Integrated Circuit Design for High-Speed Frequency Synthesis

This book is now available, as of February 2006, and as expected, some errors are being found. If you find errors in this book, or have comments about this book, please send email to cp {at} doe {dot} carleton {dot} ca. A list of errors, comments, etc will be posted. If you would rather not be acknowledged on the errata list, let us know and your name will not appear. [Comments in blue have been added since the last version of the errata updated on March 10, 2007.](#)

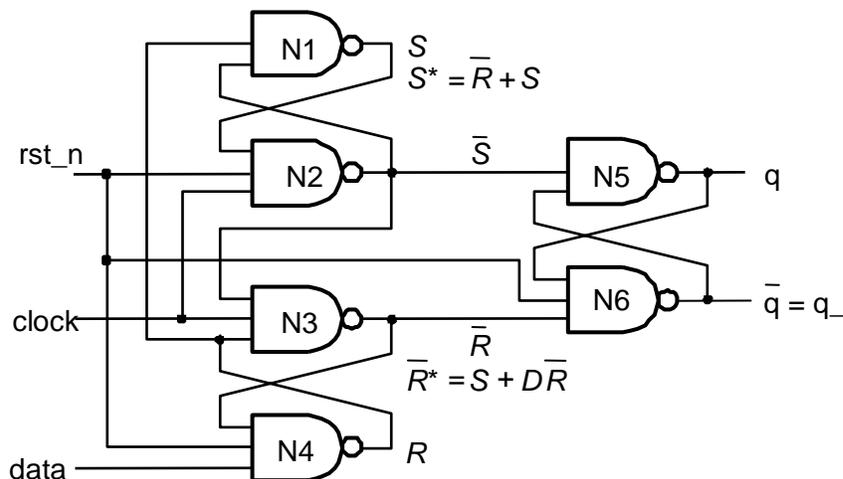
Page 90, Figure 4.3. The input to the flip-flop labeled as \bar{R} should actually be clock. Also, the bottom two nand gates should not both have outputs labeled with R, The top of these should be \bar{R} . The correct diagram is given below. (mm)

Page 90 Diagram for flip flop should have “clock” instead of “Rbar” as input. (mm)

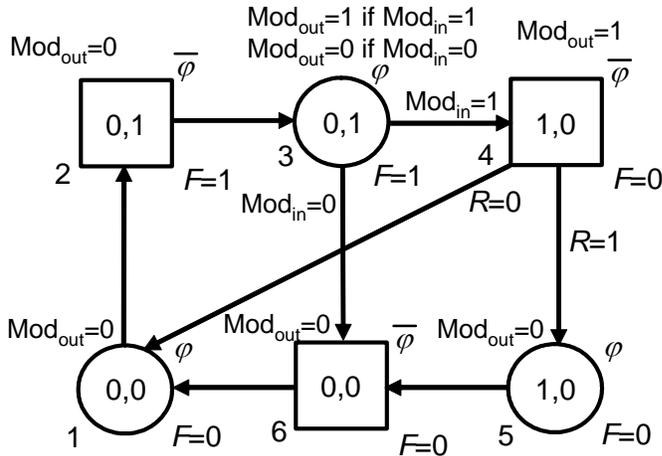
Page 166, Updated Figure 6.13 is shown below. Corrections have been made to the label at top center “Mod_{out} =0 if Mod_{in} = 0”. Also state labels 1 through 6 (starting with 1 on bottom left and increasing clockwise around the figure) have been added. (bt, jr)

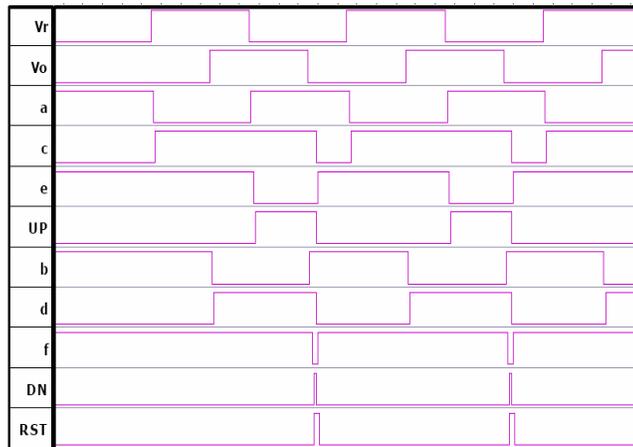
Page 191, 192, At the top left of the modified tri-state PFD is a nand gate with v_R as an input and a as the output. Whenever an input to a nand gate is low, the output must be high, yet in the plots on page 192, sometimes v_R and a are both low. Similarly, in the bottom gate, when v_o is low, b must be high, but again the plot shows times when both are low. The schematic is correct, but the output plots are in error. The correct output plot should be as shown below.
